Product Information

Changeover from RKP to RKP-II

Sizes 63, 80 and 100 cm³/rev

Advantages and characteristics of the new radial piston pump RKP-II compared to the previous RKP design

Figure 2: Comparison of the suction sides of RKP-II and the previous design RKP

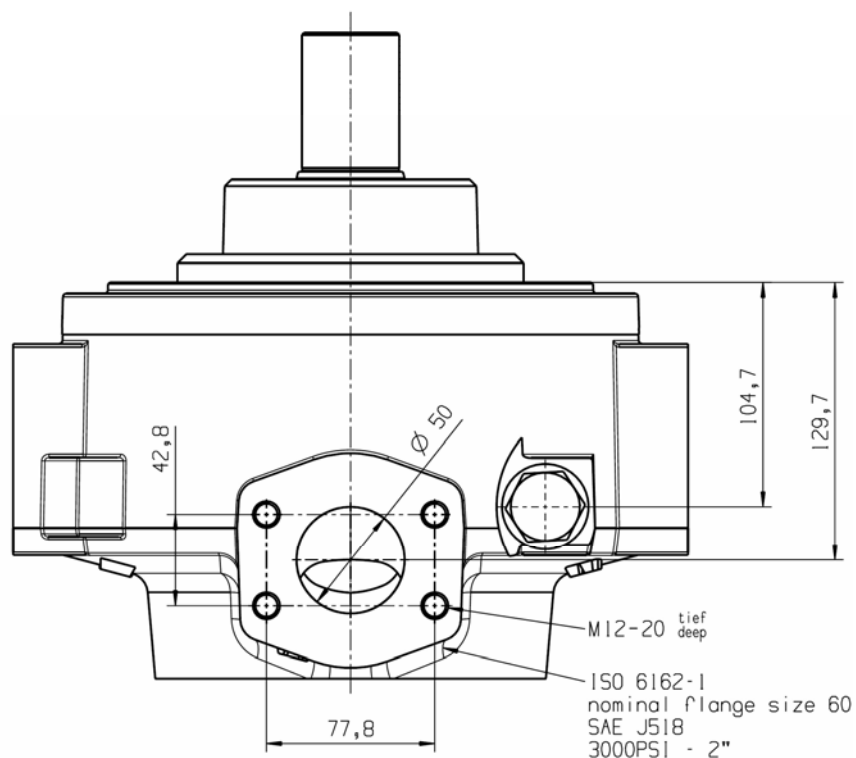
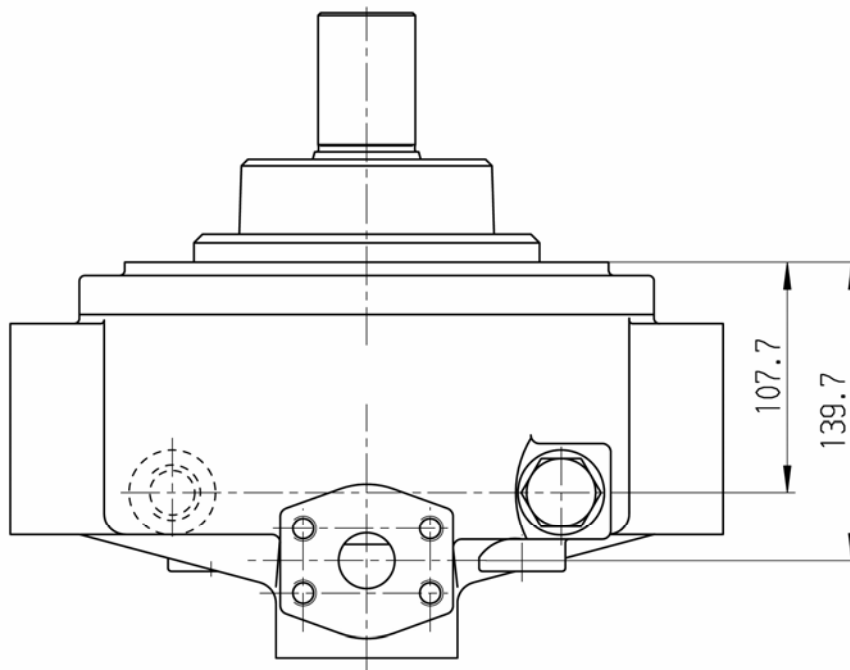
The position of the fluid ports on sizes 63, 80 and 100 cm³/rev has changed by up to 10 mm when compared to the RKP. The drawings shown in Figures 2 to 4 set out the new dimensions when compared to those on the previous RKP. Dimensions which have not changed have been omitted from this representation.

For the sizes 63, 80 and 100 cm³/rev, the suction port was enlarged to SAE 2". This enables the connection of a 2" suction pipe without the requirement for a reducing piece as needed previously. The sizes of the pressure port and the leakage ports remain unchanged.

The suction port is often connected to a solid pipe that has to match in position and size a hole in the tank cover. In this case, a suitable adapter can be used to compensate for the different flange sizes and the offset. The suction pipe must then be shortened by the thickness of the adapter. Information on such adapters are available upon request from Moog.

Figure 5: R1-type compensator of the RKP-II, sizes 63, 80 and 100 cm³/rev

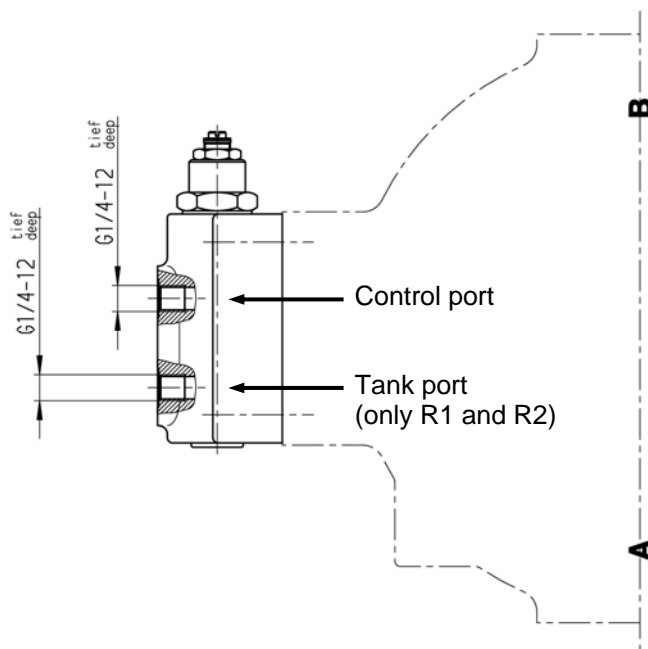
The control port connection has been changed from M 12x1,5 to G 1/4. The tank port connection (only existent in R1 and R2-type compensator) has been changed from M 14x1,5 to G 1/4, too. The position of the ports in the compensator housing remain unchanged. As an example, Figure 5 shows the R1-type compensator with the new port connections.

Fittings with G threads are available for all recommended control hose sizes. An additional adapter fitting is no longer required.
